Exhibit 13C

Letter from Captain Mohsen El Missiry, dated 7/27/00,
Egyptian Delegation comments on
Group Chairman's Aircraft Performance Study Addendum 1

Please find attached herewith, the Egyptian Delegation comments to be included in the docket with reference to the "Group Chairman's Aircraft Performance Study Addendum #1" dated April 28, 2000.

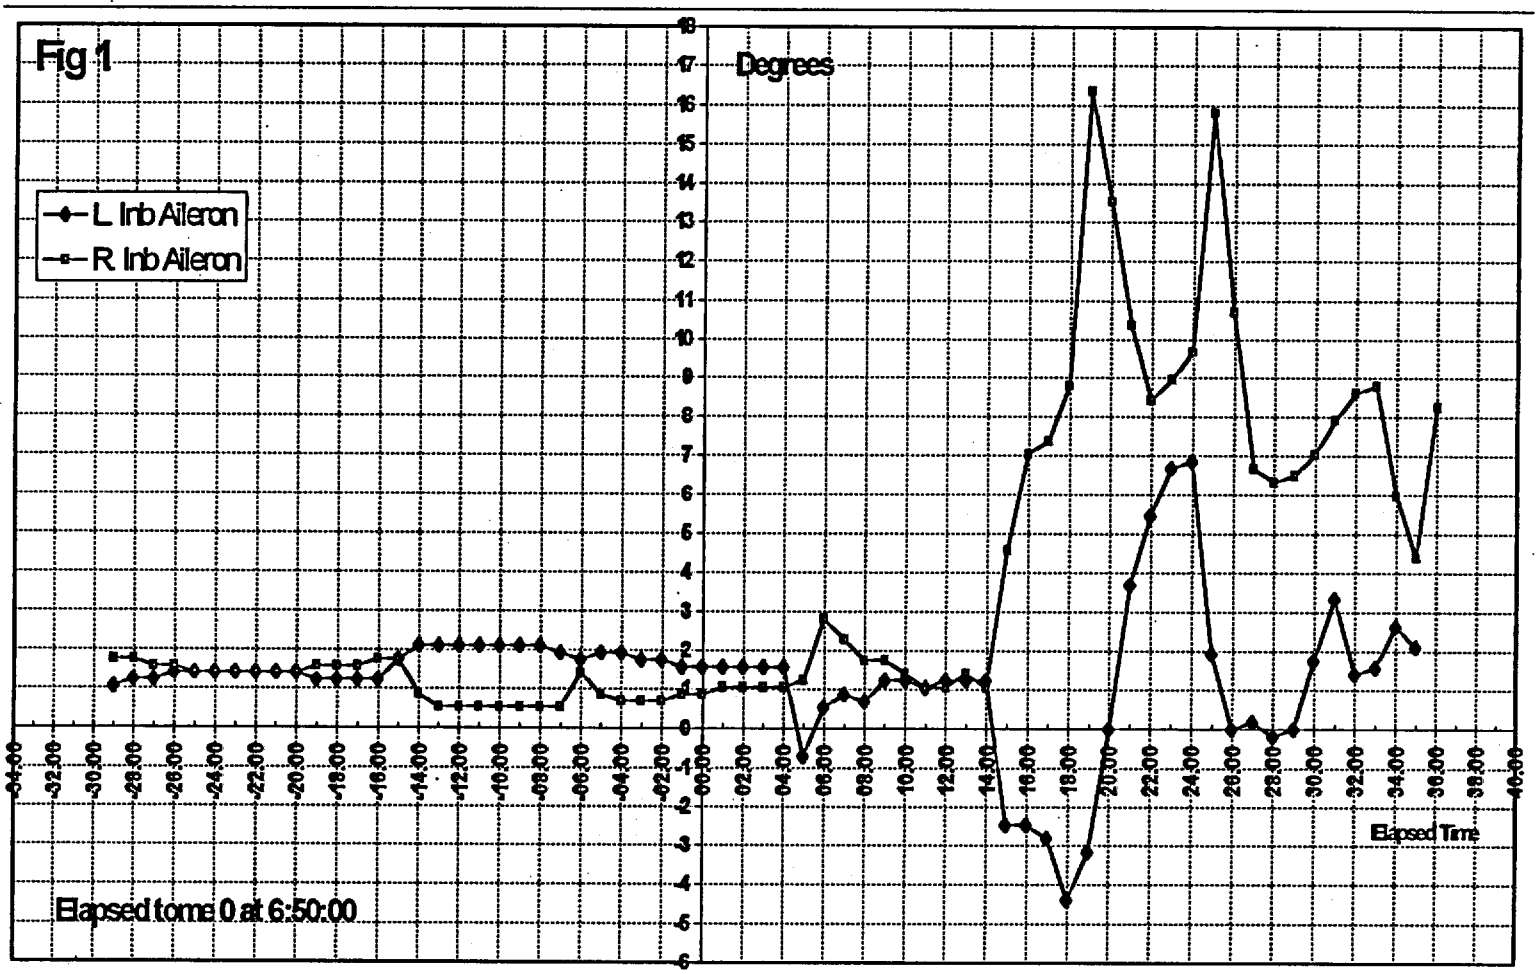
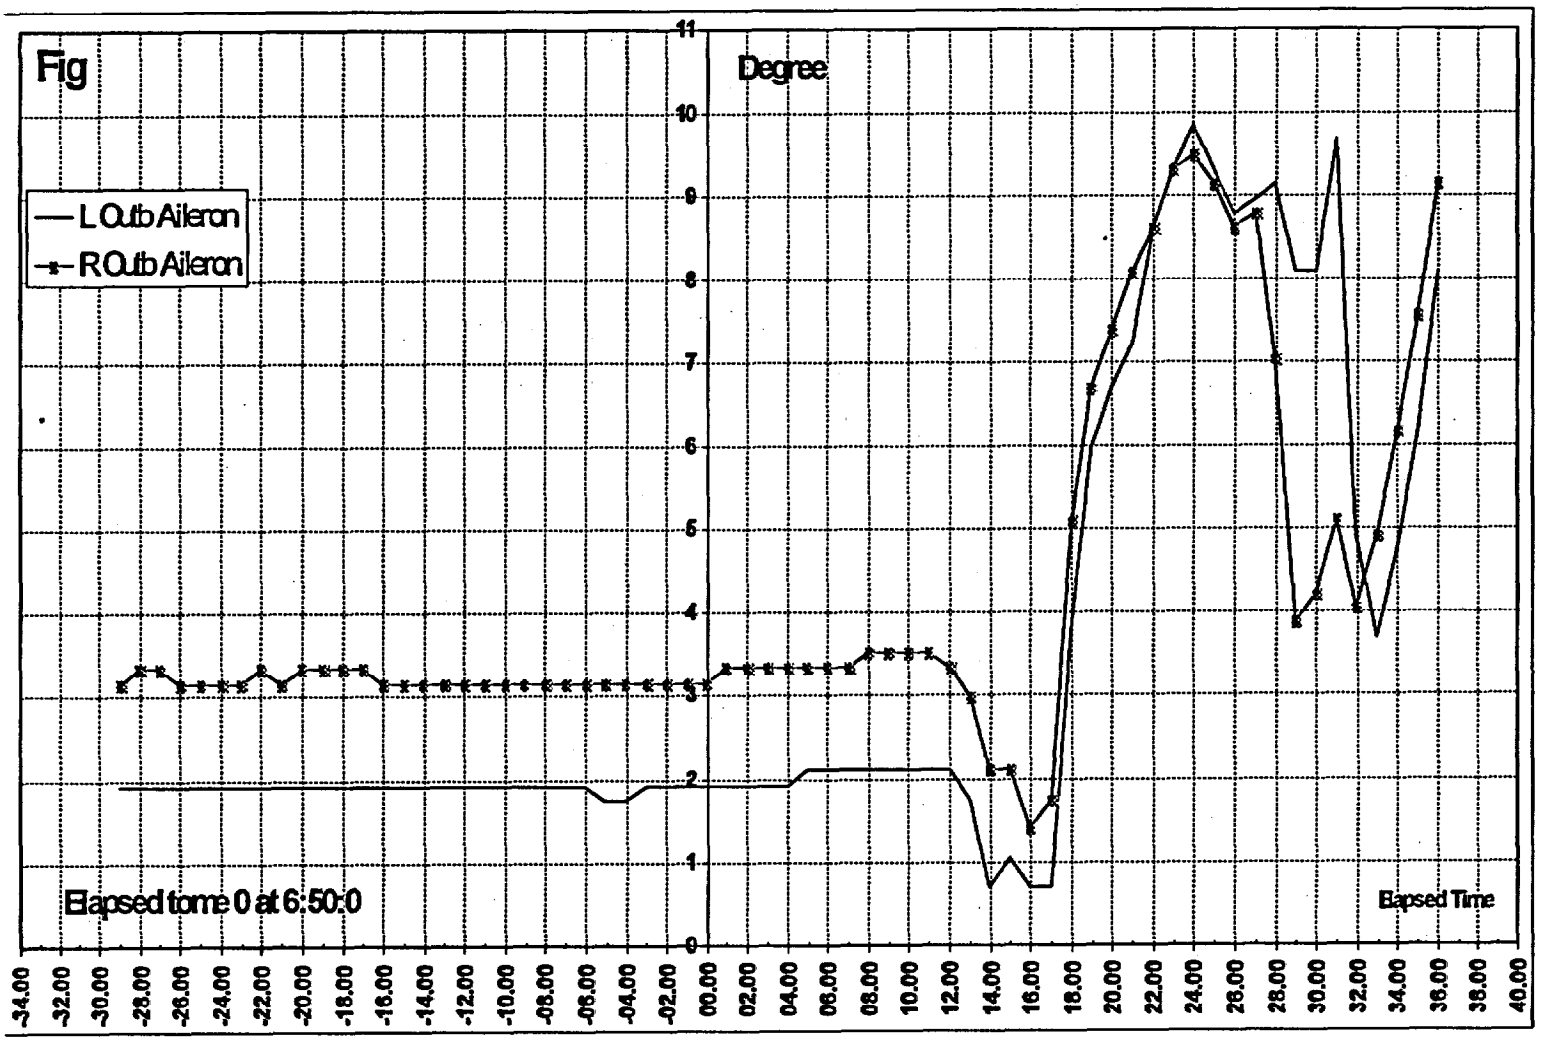
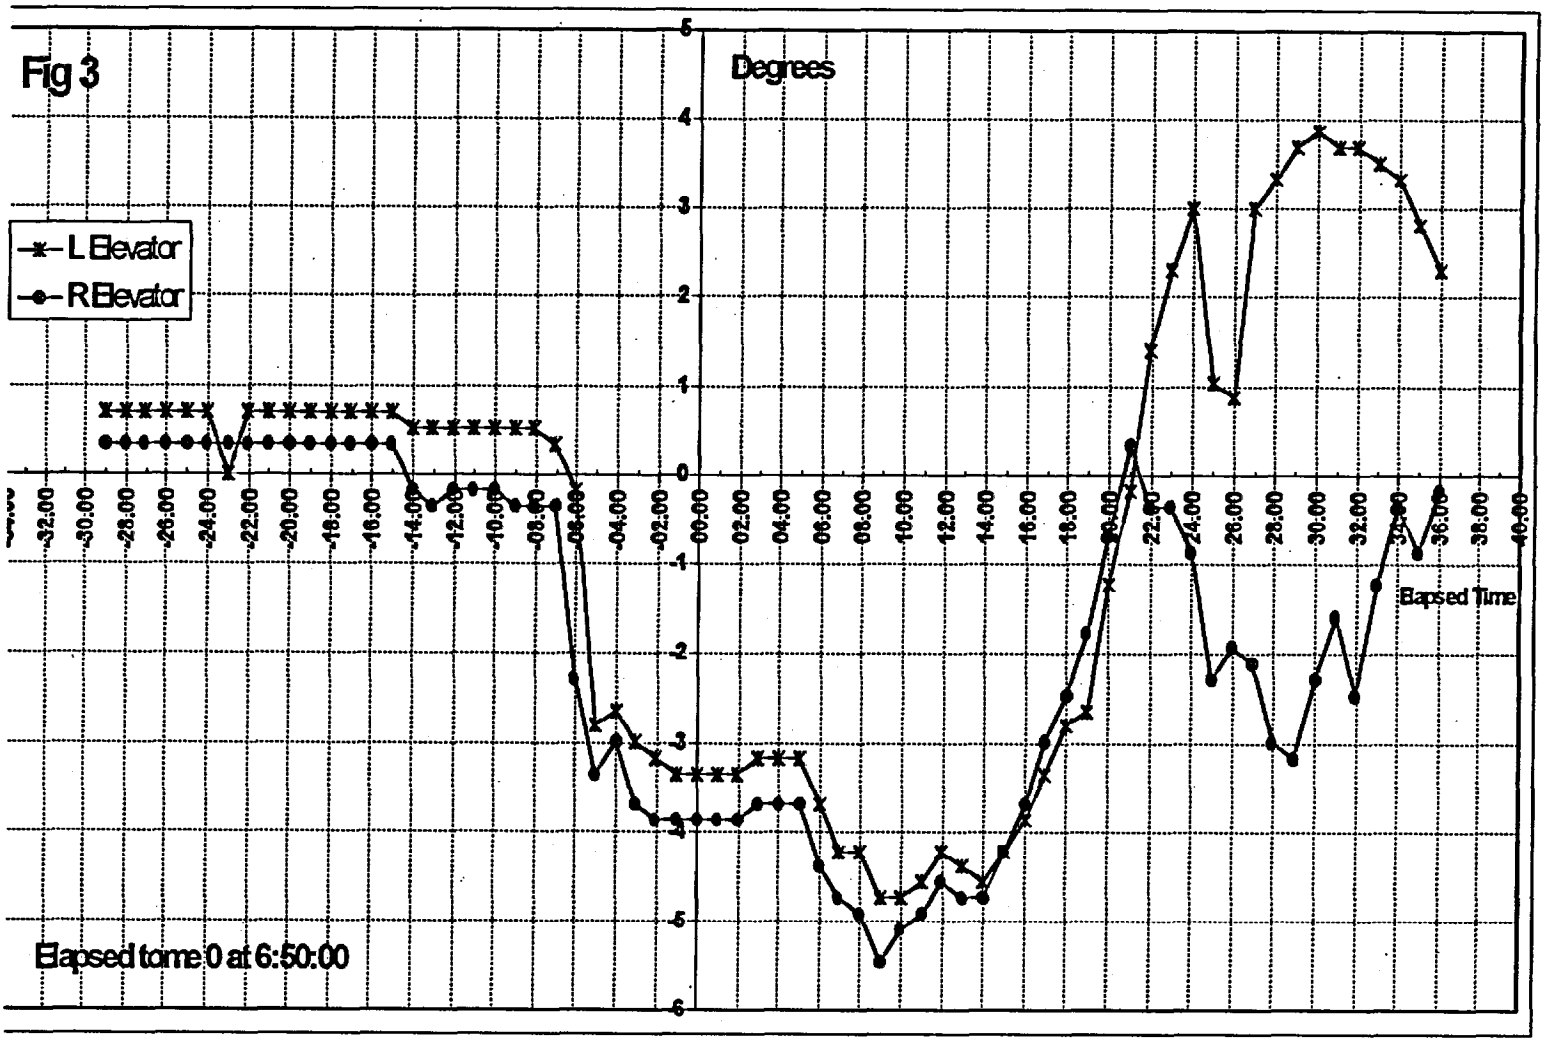
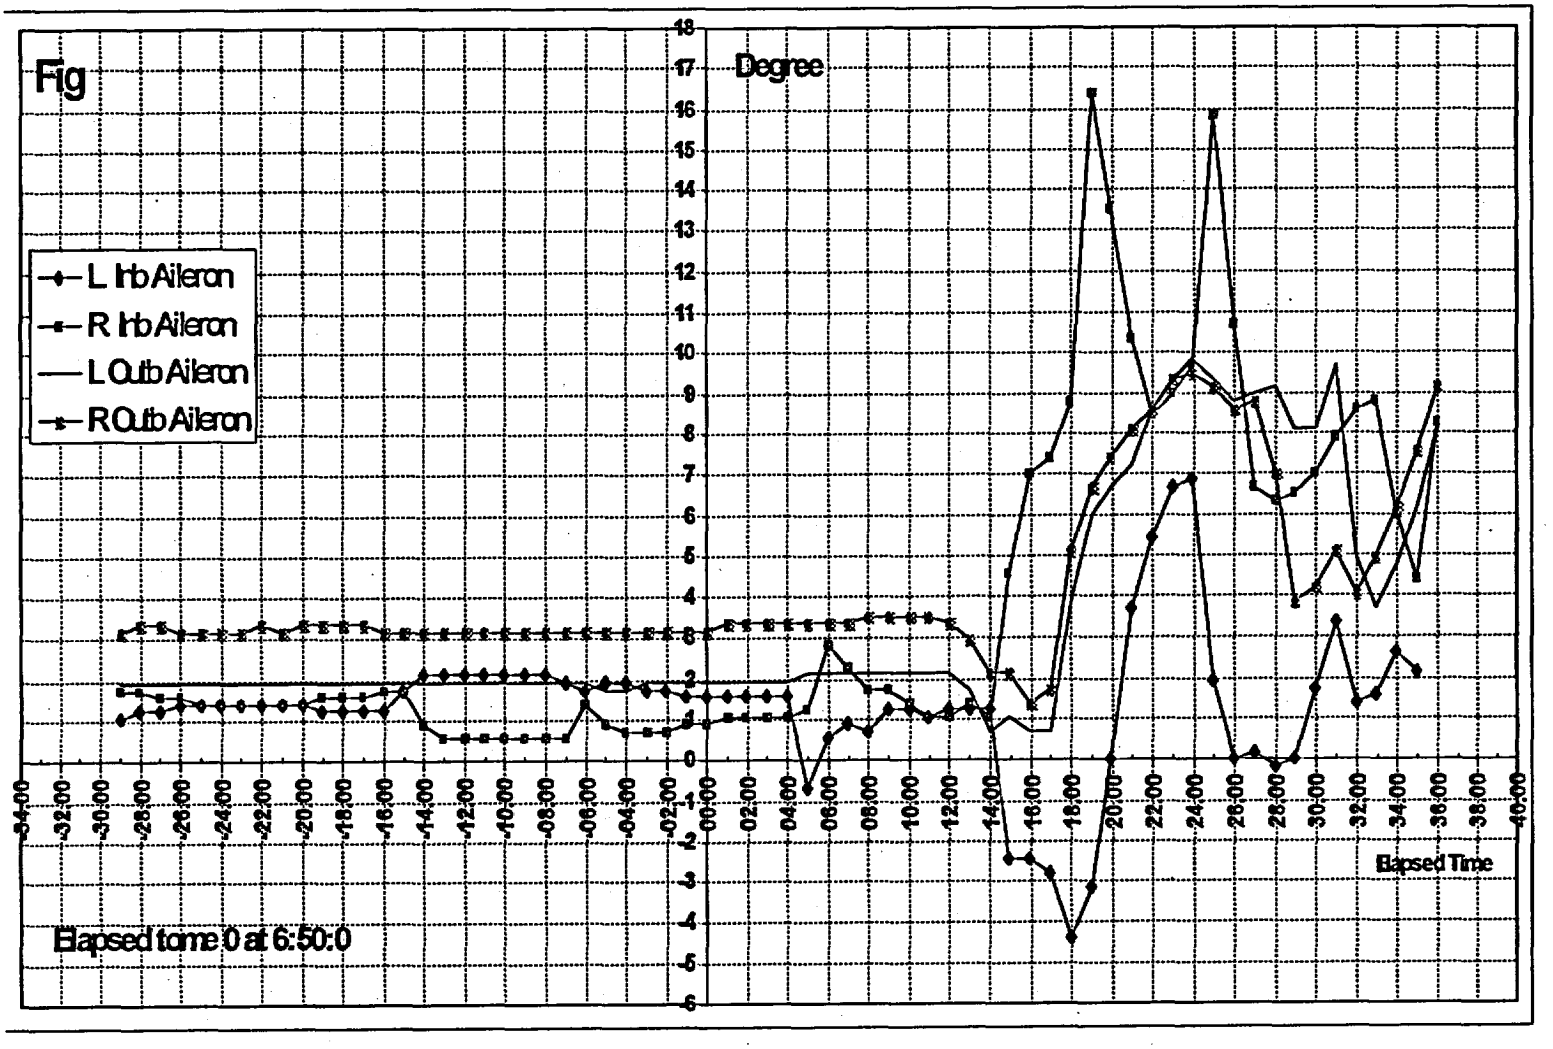
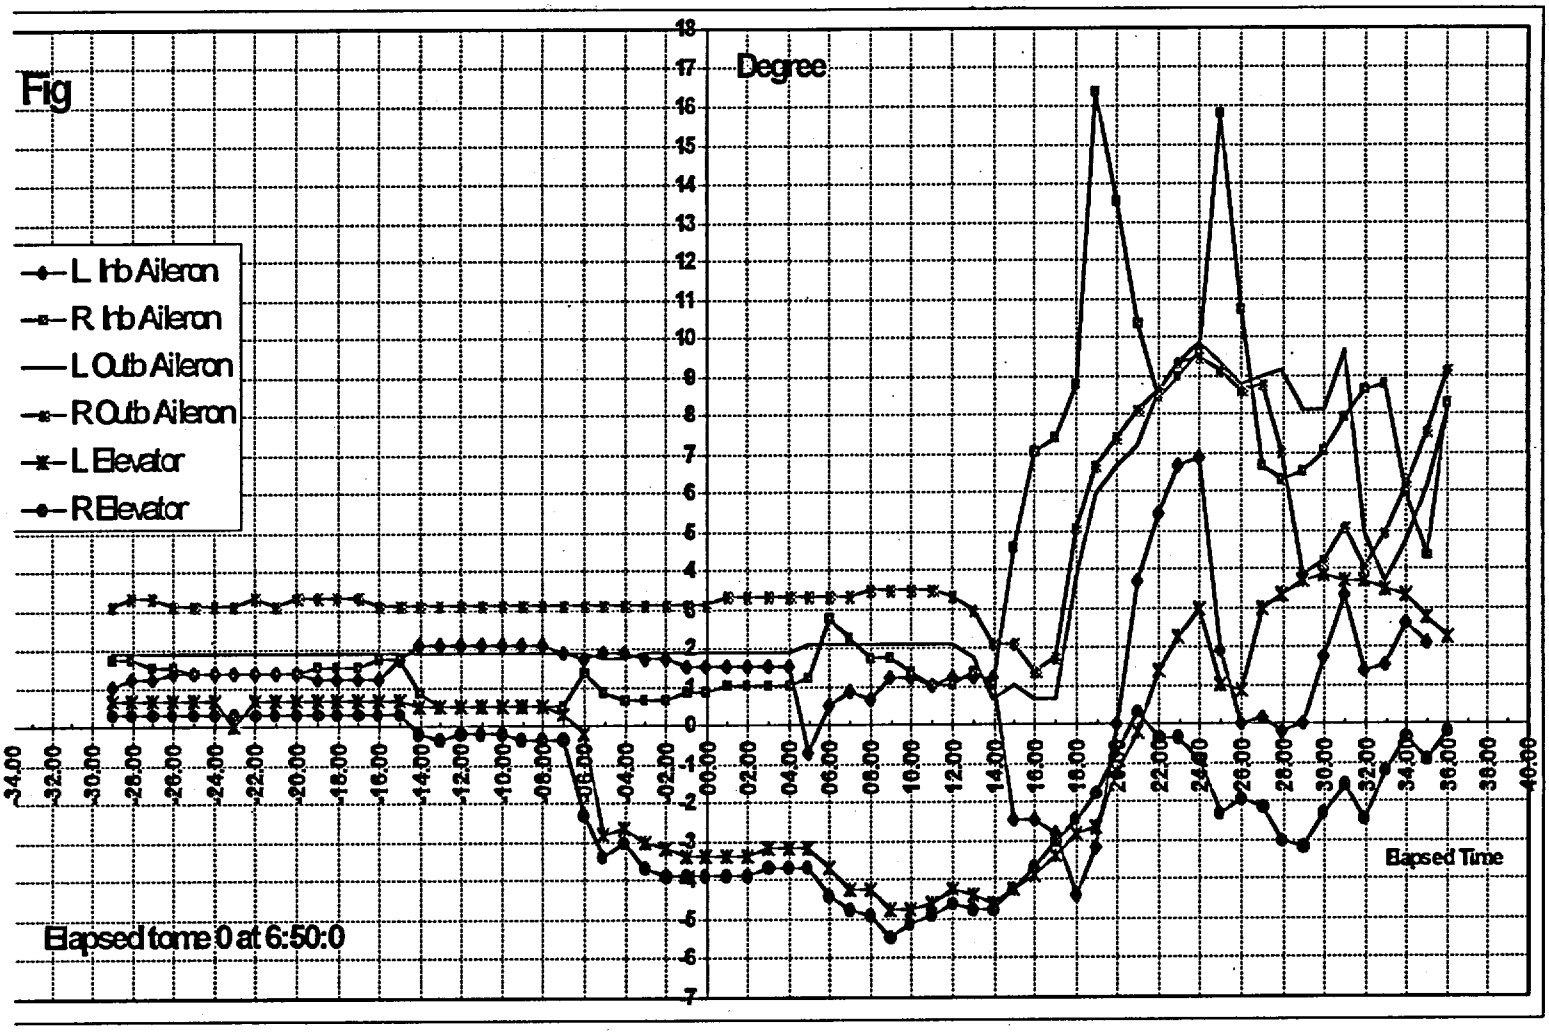
- Analysis of the FDR data showed non normal behavior of the inboard ailerons, outboard ailerons and elevators at the end of the airplane dive (figures 1 to 5)

Figure 1.

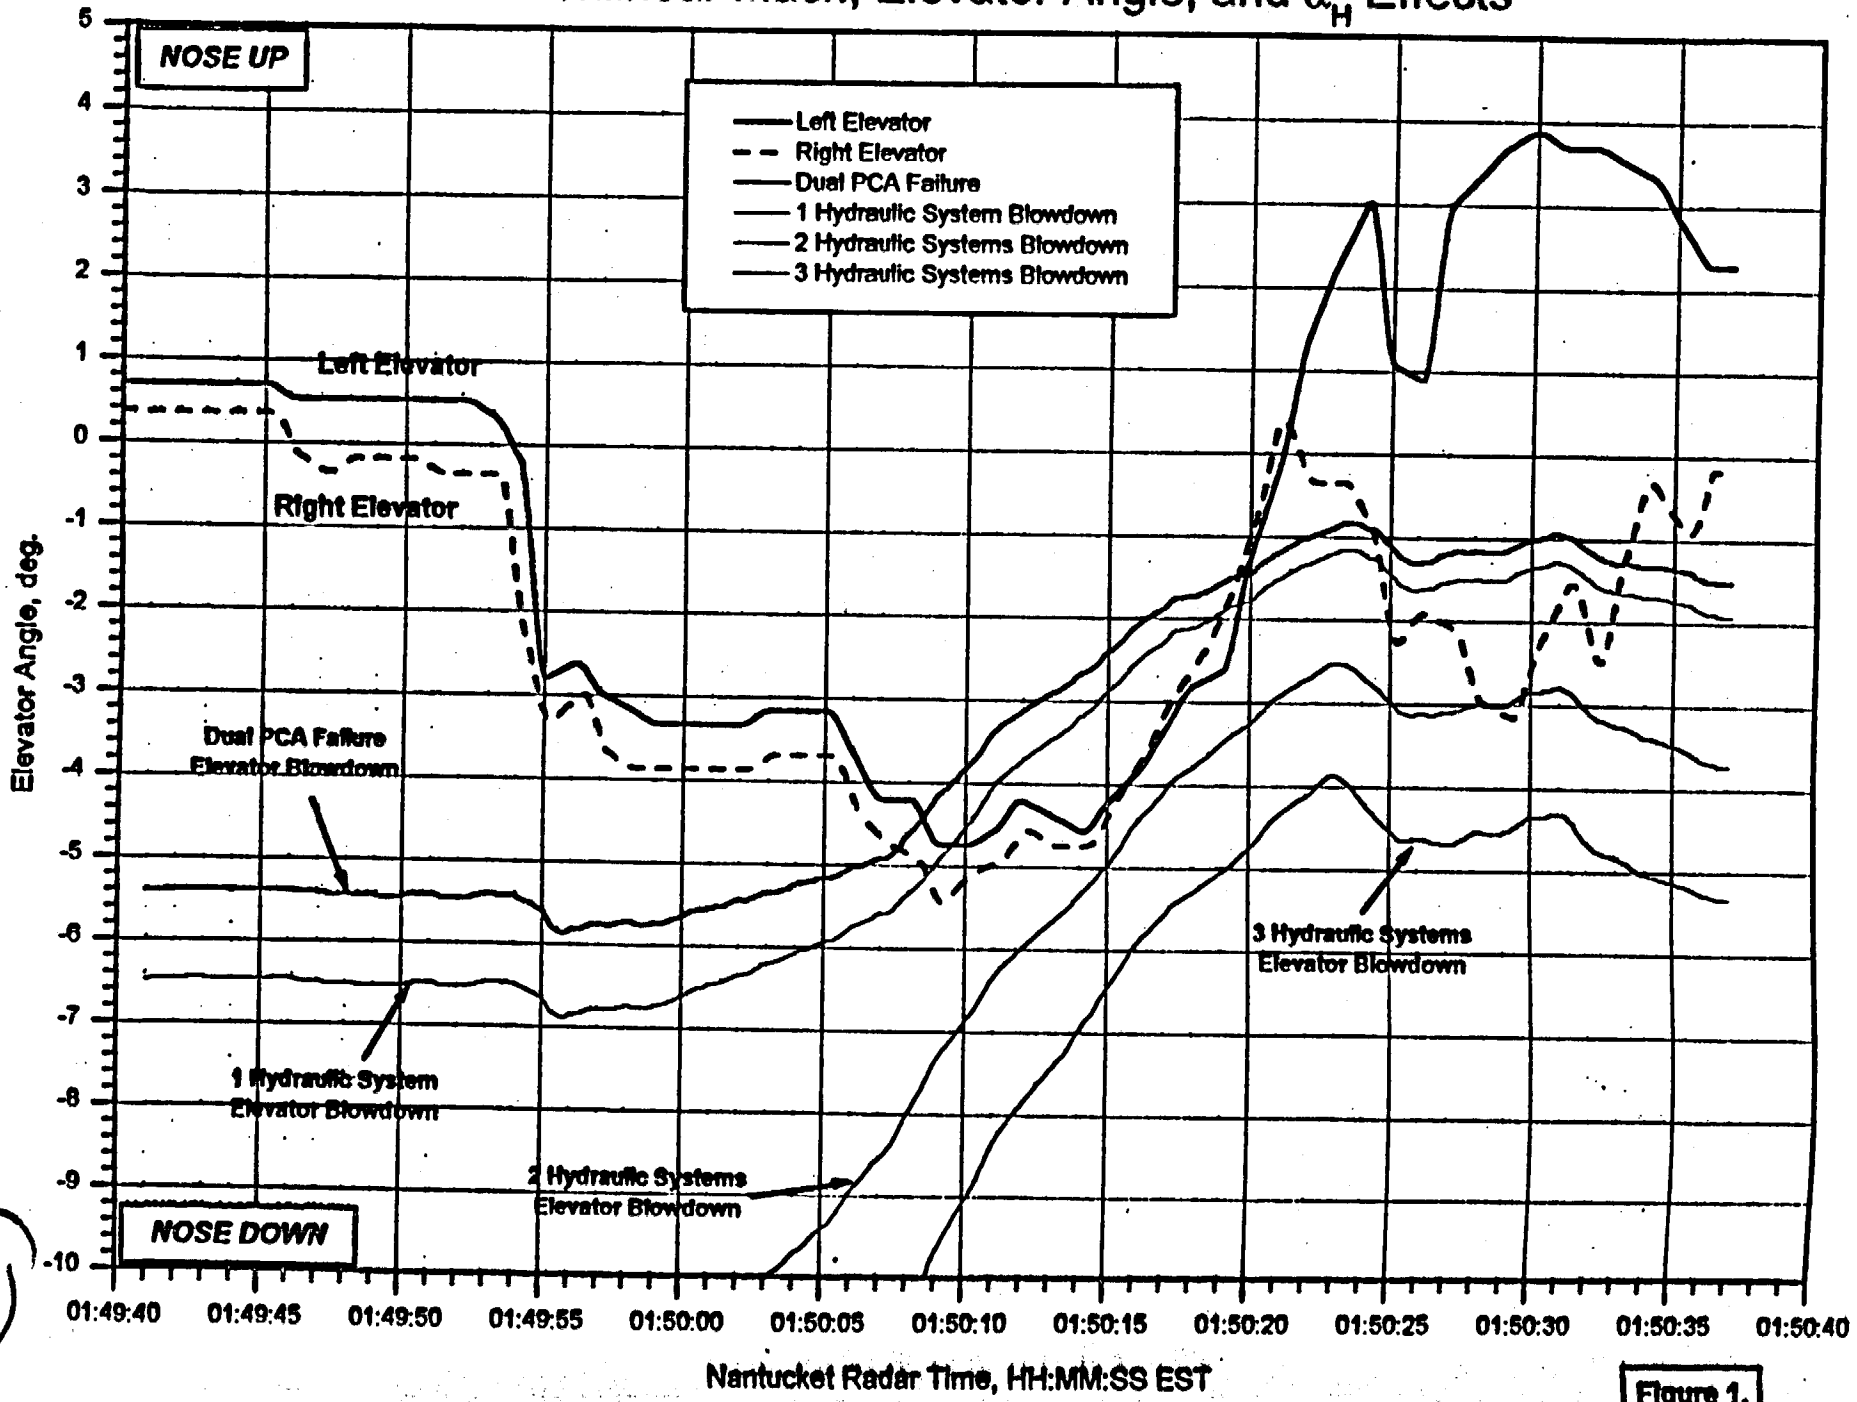
The solutions for δ_e with n = 0.78, 1, 2, and 3 are shown in Figure 1. These solutions are the blowdown angles corresponding to the Dual PCA Failure and various hydraulic systems turned off. The elevator positions recorded on the DFDR are also shown in Figure 1. The elevator blowdown angle is primarily dependent on the dynamic pressure, decreasing as dynamic pressure increases. Changes in angle of attack produce oscillations about the general trend set by the increasing dynamic pressure. Nonlinear Mach effects become more pronounced after about 01:50:07, where the Mach number is increasing through 0.86 and the slope of the blowdown curves changes abruptly. The extrapolated C_H data provided by Boeing indicates that the C_H for a given δ_e deflection starts to increase significantly above Mach 0.86, and at Mach 0.98 reaches over twice its Mach 0.8 value for some values of δ_e and α_H .
